June 1, 2009

Reference: Work Plan for Additional Assessment and Extension Request
76 (Former BP) Service Station No. 11126
1700 Powell Street
Emeryville, California 94608
Stantec Project No: 211601178.201/211402419.200

Subject: Fuel Leak Case No. RO0000066 and GeoTracker Global ID T0600100208, BP #11126,
1700 Powell Street, Emeryville, CA 94608

Figure 1: Groundwater Elevation Contours

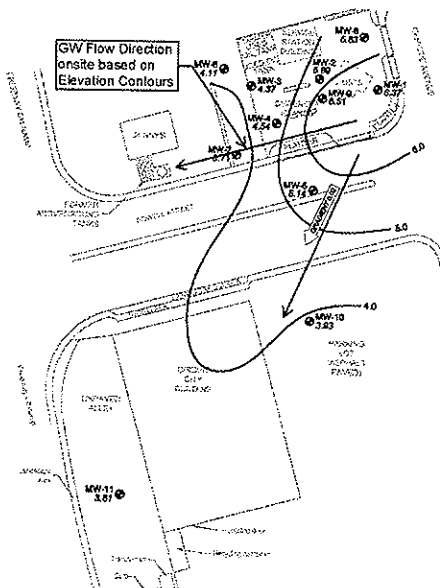
Based on the groundwater elevation contours in Stantec's January 23, 2009, "Quarterly Monitoring Progress Report Fourth Quarter 2008," it would appear that there may be at least two different gradient directions present at the site (see Figure 1). While Stantec identifies that the groundwater gradient is to the southwest, to which ACEH concurs, Stantec does not consider the possibility that there may be a westerly component of groundwater flow direction at the site, as illustrated on Figure 1. Figure 2 illustrates the TBA concentrations detected in groundwater samples collected at the site. Based on the isoconcentration contours, the down-gradient extent of the TBA plume appears undefined in the direction of the plume axis. Concentrations of TBA in monitoring well MW-7 appear to have been increasing in the recent past with TBA being detected at 3,500 µg/L during the fourth quarter 2008 monitoring event. Since concentrations of TBA appear to be increasing and the extent of the contaminant plume in the western direction appears undefined, based on groundwater elevation contours and TBA isoconcentration contours, a work plan to define the extent of the groundwater contaminant plume is required. Please propose a scope of work to address the above-mentioned concerns and submit a work plan due by the date specified below.

The proposed scope of work will consist of the installation of one off-site groundwater monitoring well (MW-12) to a depth of 25 feet below ground surface (bgs) at the location shown on Figure 1. The proposed scope of work for this site assessment additionally includes hand auger exploratory borings and soil sampling at three locations (SB-1 through SB-3) to investigate shallow soil at the site (Figure 2). Boring locations have been located adjacent to previous soil sampling locations and outside of previous excavations to provide for comparison to historic soil sampling results. A summary of the field work is presented below. Field and laboratory procedures are provided in Attachment C. Historical soil analytical data is presented in Attachment D.
